Item Name: Replacement Skidtube (Fits LH or RH)

DRAWING NO. D2650	TITLE 206/407 SKIDTUBE ASSEMBLIES	REV. F	DART AEROSPACE LTD ENGINEERING ORDER		D.E.O. NO. D2650-F-1	SHEET NO. SHEET 1 OF 1	SCALE NTS
DRAWN	CHECKED A.P.	MFG. APPR.	APPROVED	DE APPR.			
DATE 12.10.12	DATE 12.10.22	DATE 12.10.22	DATE 12.10.22	DATE 12.10.22

PURPOSE:

CHANGE C'BORED WELDED CROSSBOLT SPACERS TO SWAGED SPACERS

DETAIL G

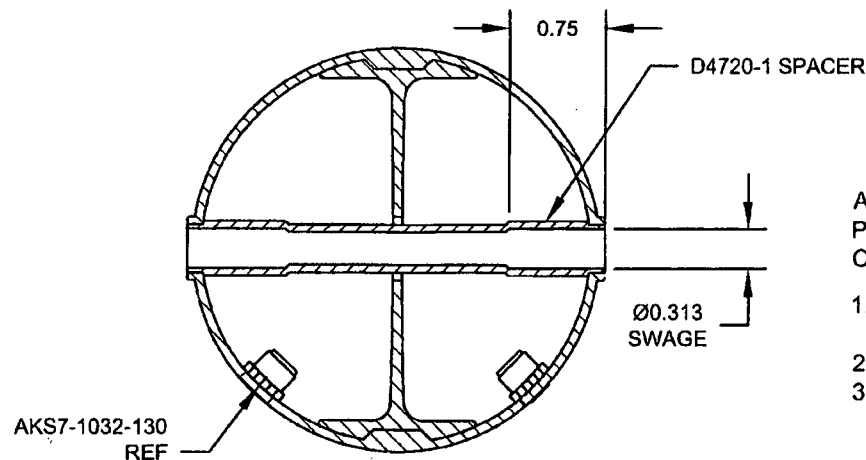
ADD DETAIL G BELOW, WHICH IS THE SAME SECTION VIEW AS DETAIL D OF DWG.

C'BORED HOLES ARE **NOW SWAGED** PER DETAIL G BELOW. FOR THE Ø0.375 HOLE THAT IS NOT C'BORED, WELD PER DETAIL D OF DWG (SEE AMENDED DETAIL B FOR REFERENCE).

AFTER DRILLING AND BENDING ASSEMBLY
PERFORM THE FOLLOWING FOR Ø0.375 HOLES THAT ARE
CURRENTLY C'BORED:

1. INSERT D4720-1 SPACER, 16 PL (-1) OR 17 PL (-3)
OR 19 PL (-5) OR 23 PL (-7)
2. SWAGE TO Ø0.313 X 0.75 DP PER QSI 002
3. TRIM / GRIND FLUSH PER QSI 002

AMENDMENT TO DETAIL B
NOT TO SCALE

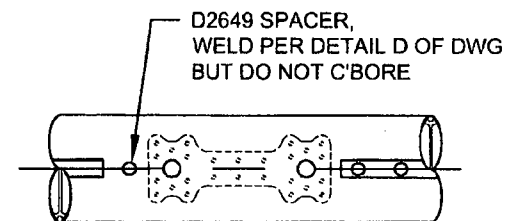
FOR HOLES THAT ARE CURRENTLY C'BORED ONLY
NOT TO SCALE
